WCAP-17524-NP  
Revision 1

March 2014

# AP1000 Core Reference Report

Figure 2-1 Comparison of the Previous Protective Grid and the RPG

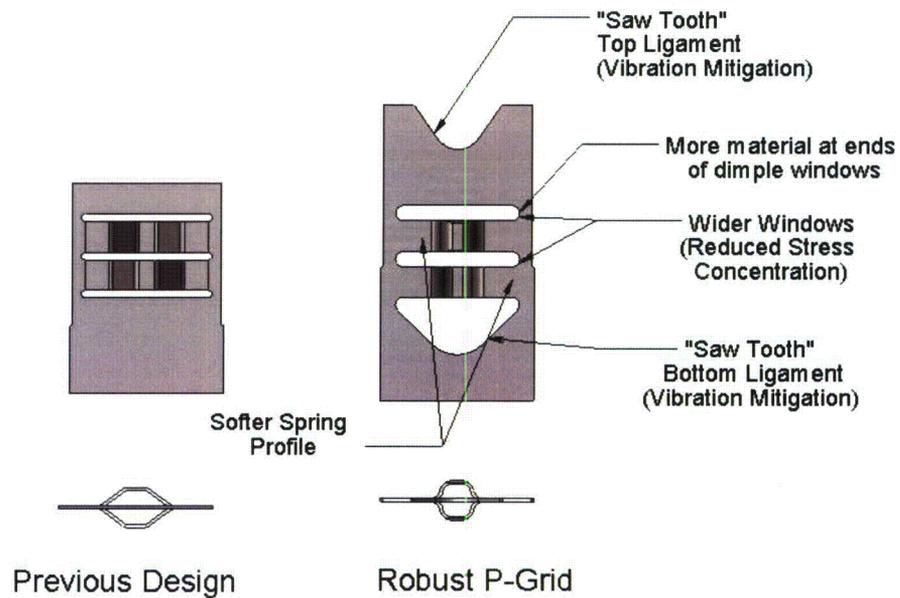
Figure 2-1 provides an illustrative comparison of the inner grid straps between the previous P-grid design and the RPG design. Figure 2-2 shows the difference in the number of supports used on the previous P-grid design versus the RPG design.

Figure 3-1 AP1000 PWR Advanced First Core (AFC) Loading Pattern

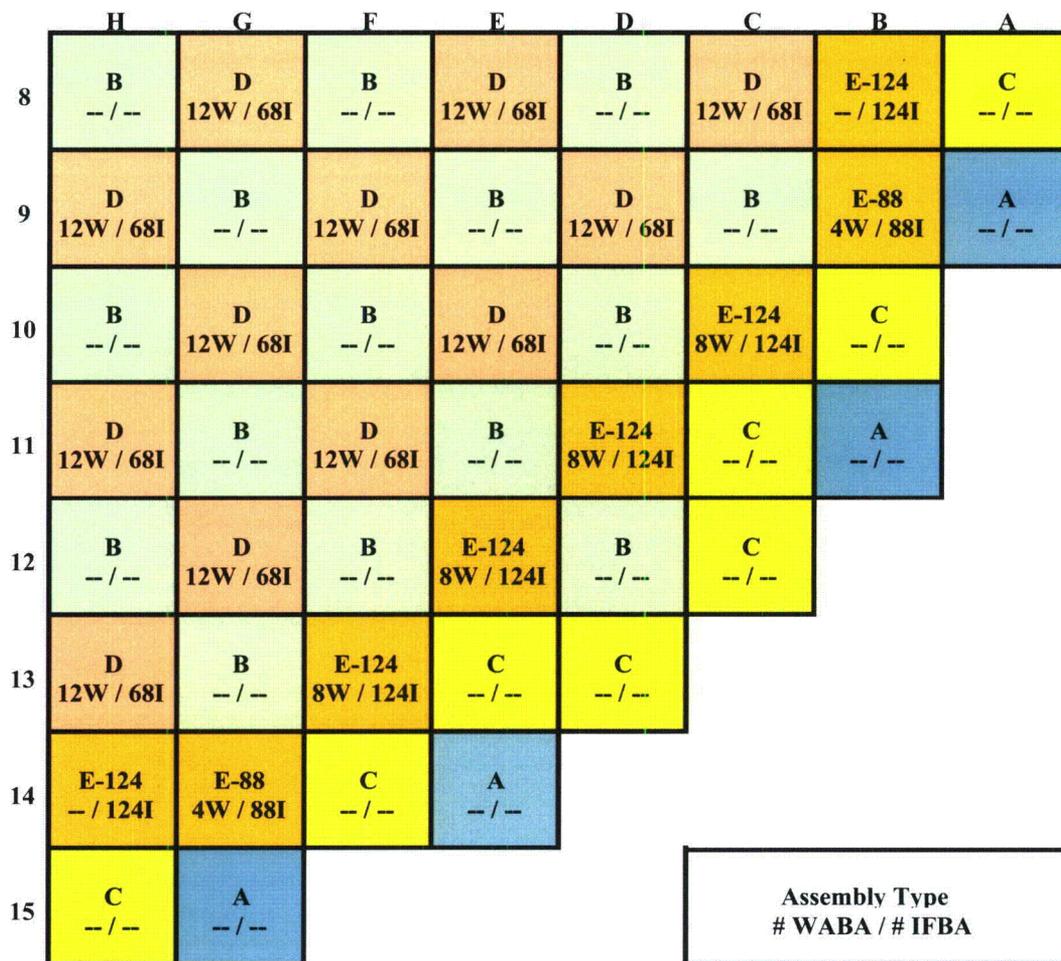
Based on customer requests for improved uranium utilization and the requirements for plant standardization, Westinghouse developed the AFC design, which is illustrated in quarter core geometry in Figure 3-1 (lower-right quadrant). The AFC design was developed to more closely resemble a modern, reload core design using a low leakage loading pattern (L<sup>3</sup>P) strategy. This is accomplished by using a 5-region first core design, [

Figure 4.2-5

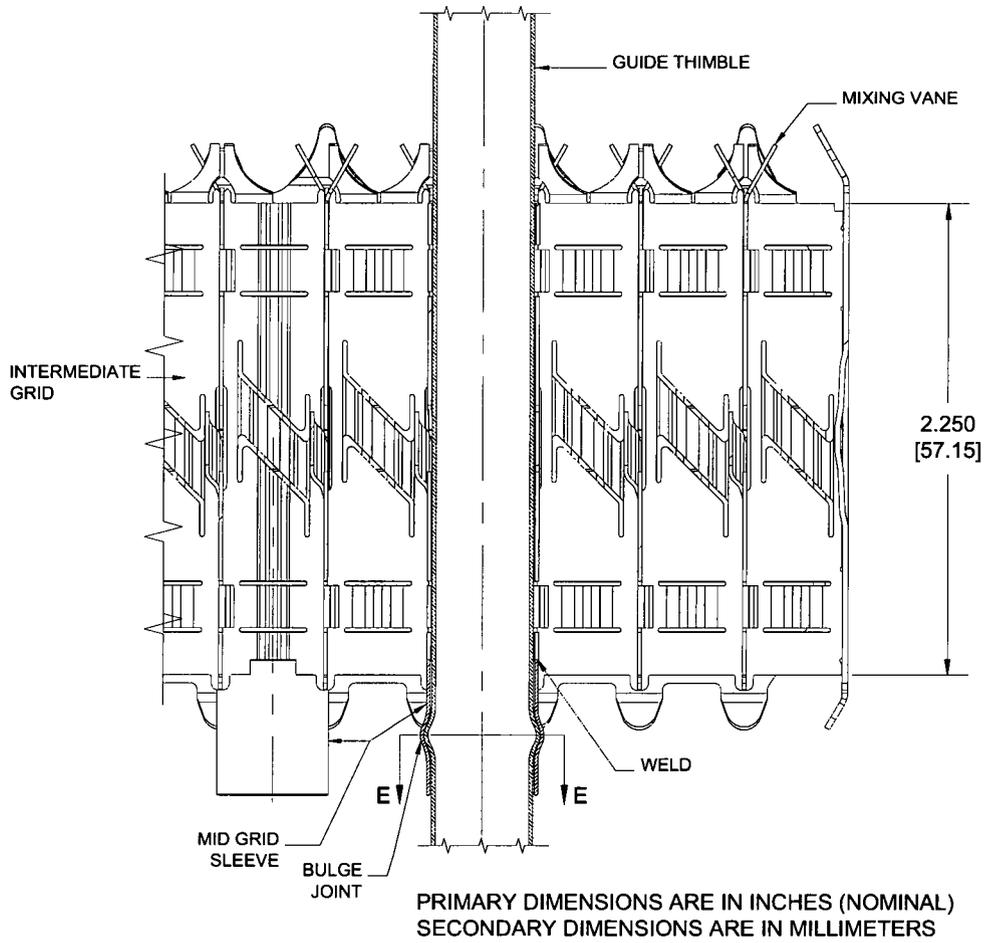
[4.2-56]	Figure 4.2-5	Figure has been redrawn with grid height dimension added consistent with DCD Revision 19 which stated that the dimension will be provided in the Core Reference Report. Metric units have also been added. The basic content of this figure has not been changed.
[4.2-57]	Figure 4.2-6	Figure has been redrawn with dimensions added consistent with DCD Revision 19 which stated that the dimension will be provided in the Core Reference Report. Metric units have also been added. The basic content of this figure has not been changed.
[4.2-58]	Figure 4.2-7	Figure has been redrawn. With the exception of the number of P-Grid spacers (changed from 4 to 8), the basic content of this figure has not been changed.
[4.2-59]	Figure 4.2-8	Figure has been redrawn to remove any stray marks. No changes have been made to the content of this figure.
[4.2-60]	Figure 4.2-9	Figure has been updated based on enhanced RCCA design options. Metric units have also been added.

Figure 4.2-10

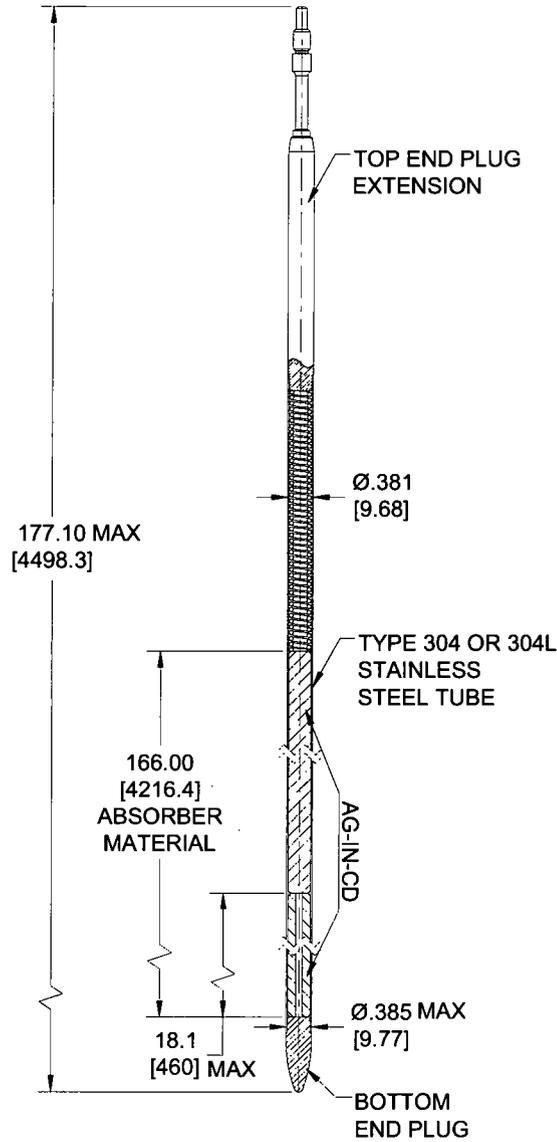
[4.2-61]	Figure 4.2-10	Figure has been updated based on enhanced RCCA design options. Metric units have also been added.

Figure 4.2-11  
 Gray Rod Cluster Assembly

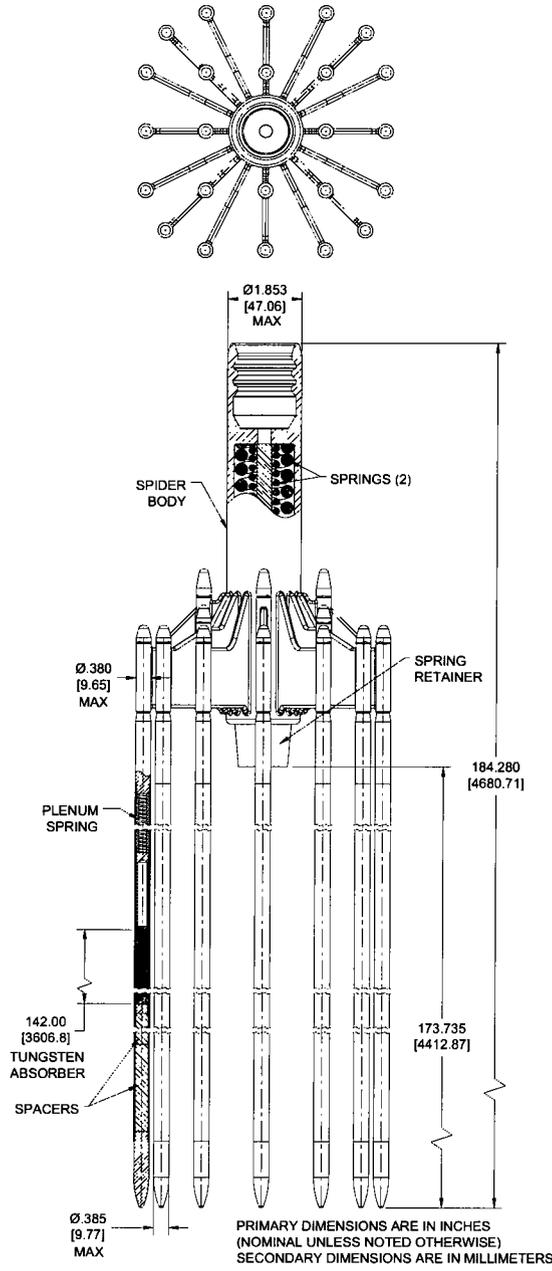
[4.2-62]	Figure 4.2-11	Figure has been updated based on enhanced RCCA design options and tungsten GRCA design. Metric units have also been added.
[4.2-63]	Figure 4.2-12	Revised figure from "Discrete Burnable Absorber Assembly" to "Wet Annular Burnable Absorber Assembly" consistent with the advanced first core design change as described in sub-section 4.2.2.3.3.
[4.2-64]	Figure 4.2-13	Deleted figure of "Burnable Absorber Rod Assembly (Pyrex) Borosilicate Glass" and replaced with "Not used" consistent with the advanced first core design change as described in sub-section 4.2.2.3.3.
[4.2-65]	Figure 4.2-14	Figure has been redrawn and metric units added. The basic content of this figure has not been changed.
[4.2-66]	Figure 4.2-15	Figure has been redrawn and metric units added. In addition, the source length has been corrected from 97 to 88 in. for consistency with Section 4.2.2.3.4, which already correctly specified the length as 88 in.
